This is to certify that COLESWORTHY PETER L / Peter Anders
has permission to new 336 sq ft screened porch, 200 sq ft 1 story addition, enlarge existing bedroom, add bathroom, & 68 sq ft enclosed addition
AT 370 SUNSET RD. Cliff Island CB# 109C-A037001

City of Portland, Maine - Building or Use Permit Application

Permit No: 09-0642	Issue Date:	CBL: 109C A037001
-----------------------	-------------	----------------------

COLESWORTHY COTTAGE
ADDITIONS & RENOVATIONS
CLIFF ISLAND MAINE

A1.1
 PERMIT SET

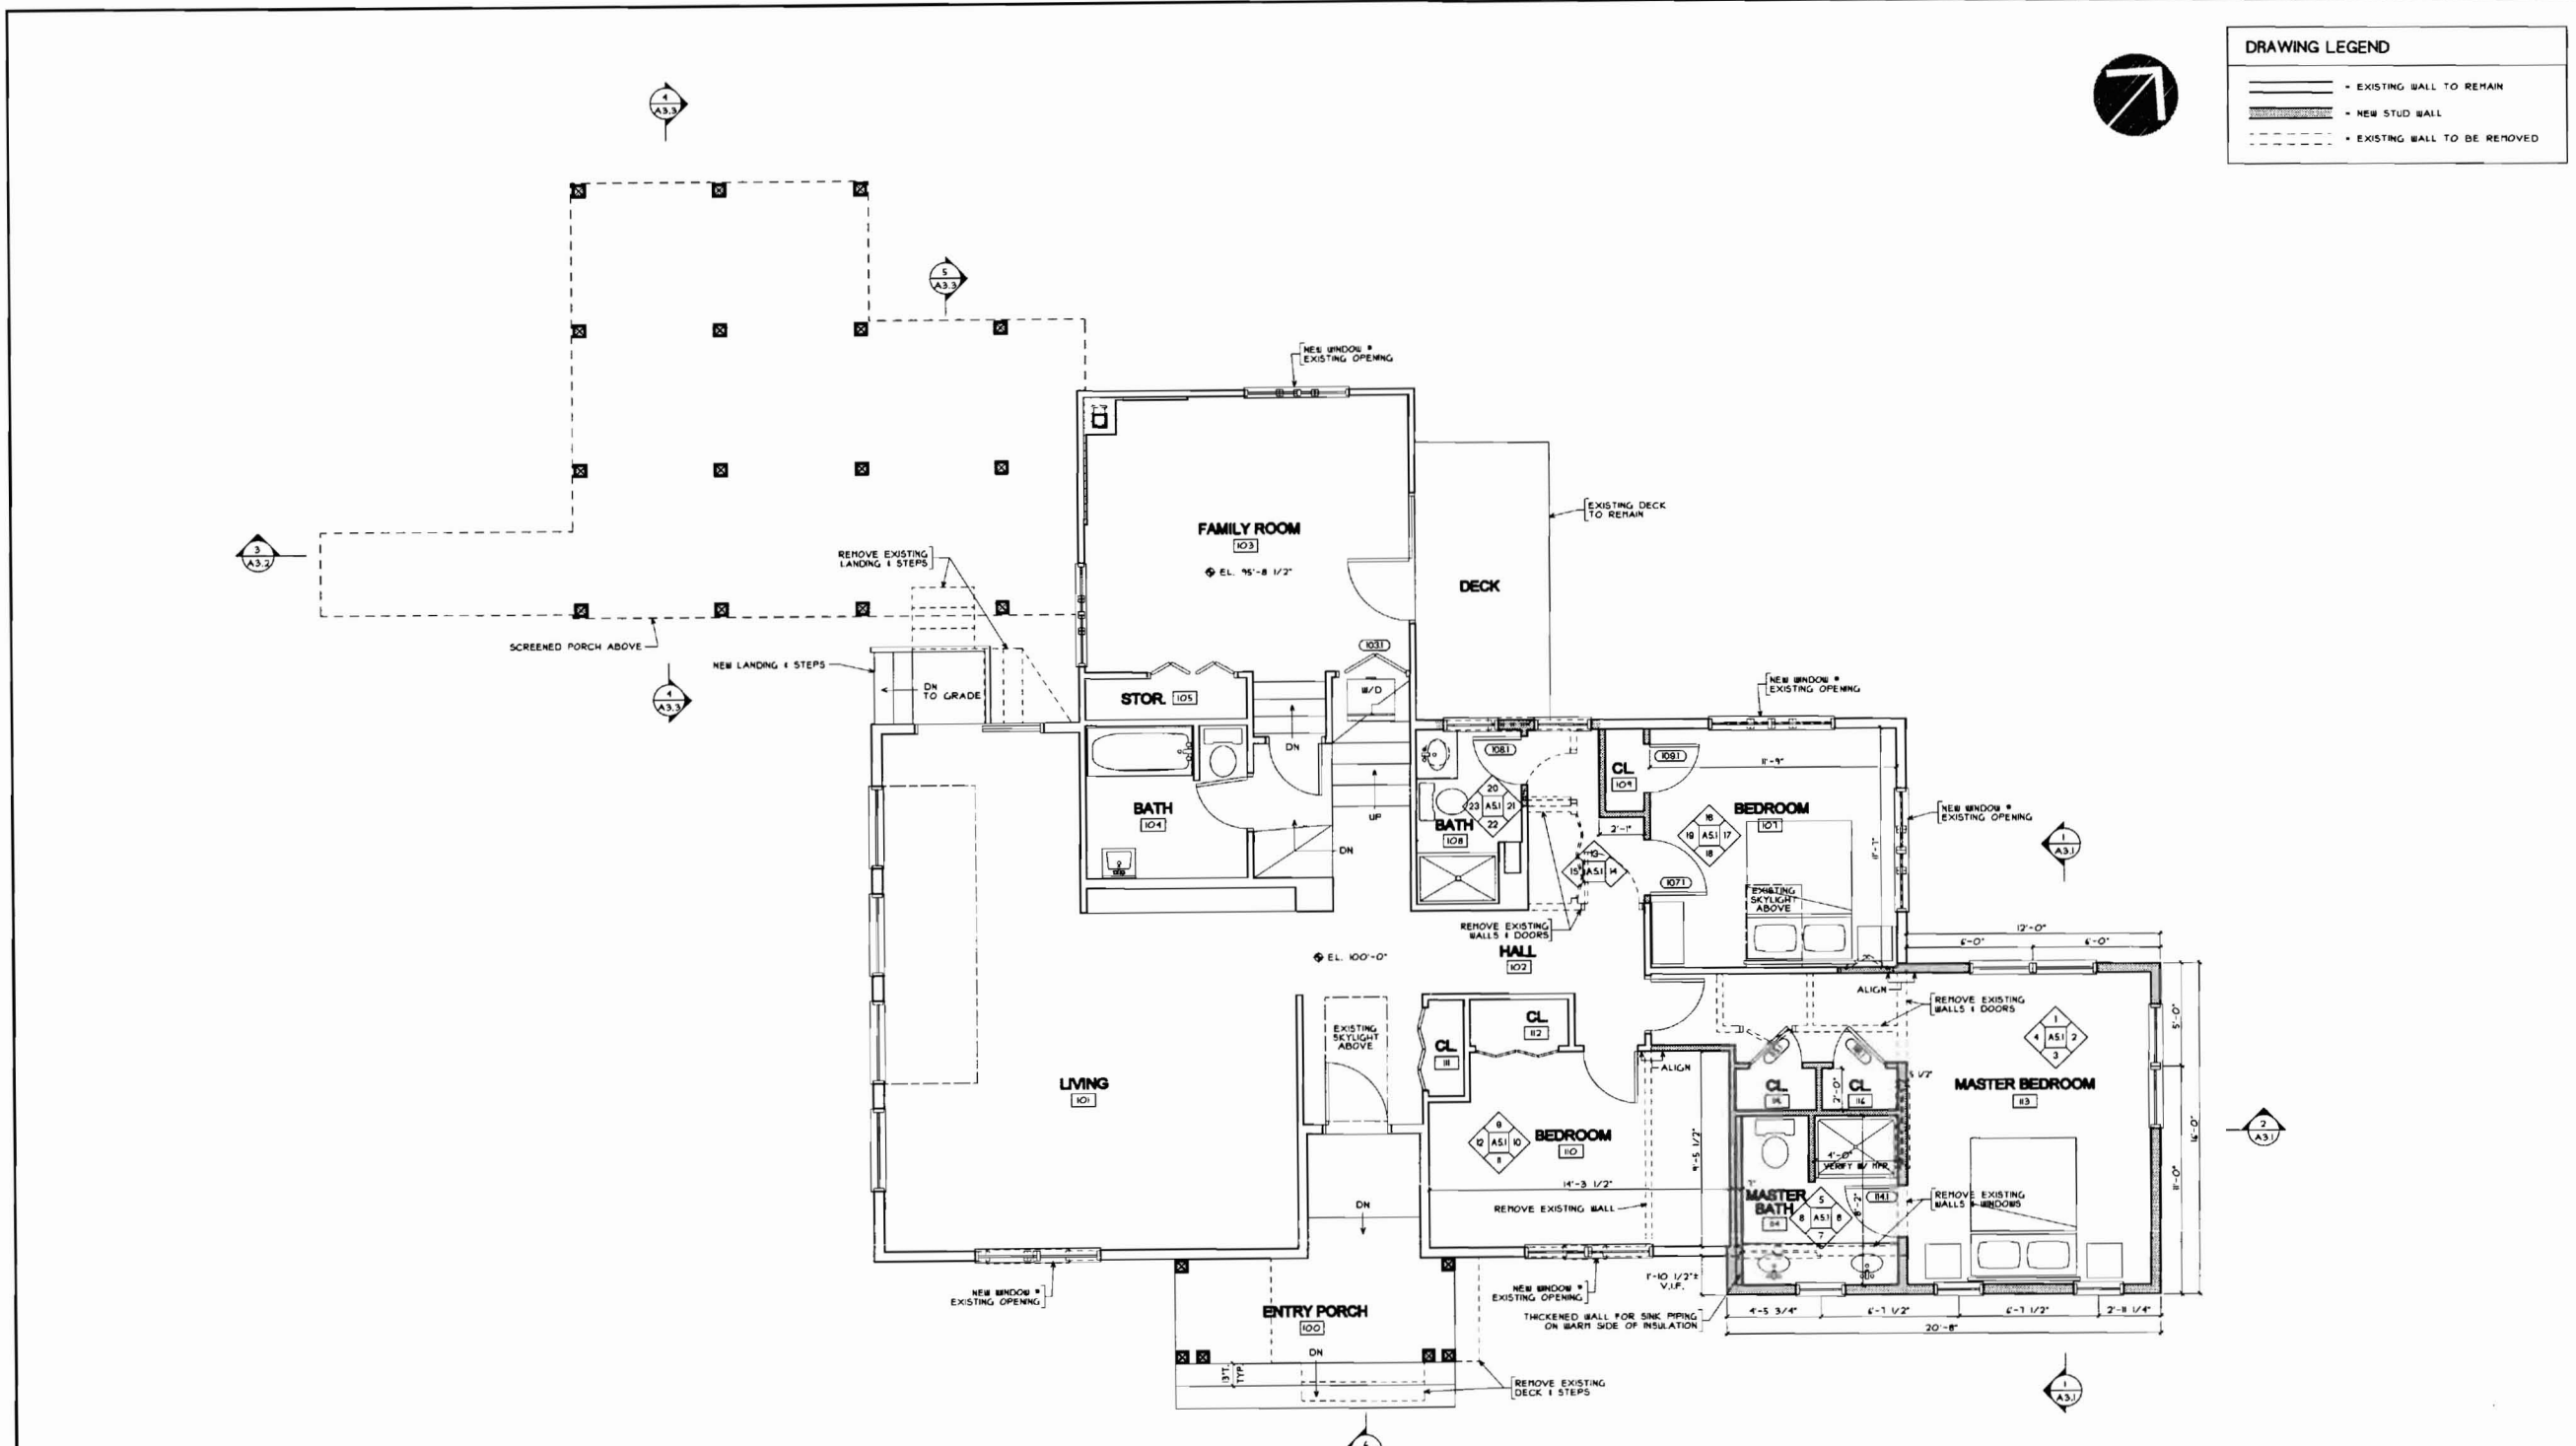
Comments:
6/26/2009-amachado: Left message For Steve Blatt. Deck on A1.1 "existing deck to remain is not permitted & within 75' setback. Need updated survey of location of 75' setback from highest tide for 2009.
7/1/2009-amachado: Spoke to Steve Blatt. Told him that the existing deck was not permitted. Told him that the 75' shoreland setback was located in 2006. Upland edge of coastal wetland is based on area that is subject to tidal action during max. spring tide as identified in tide tables published by national Ocean Service. Since the additions are close to the 75' setback, need to know what it would be for 2009 based on the tide tables for 2009. He said that he would pass the information on to the owner.
7/8/2009-amachado: Spoke to Peter Colesworthy. He had no idea that the deck was not permitted. It will be removed and be replaced by steps to grade per code. New plans will be submitted that show this. He is planning to contact Bob Greenlaw to update the 75' setback from the highest annual tide to make sure that the proposed additions are outside the 75' setback.

9/15/2009-amachado: Received revised siteplan on 9/9/09 that showed 75' setback for shoreland and the proposed additions. Went over them with Steve Blatt today.
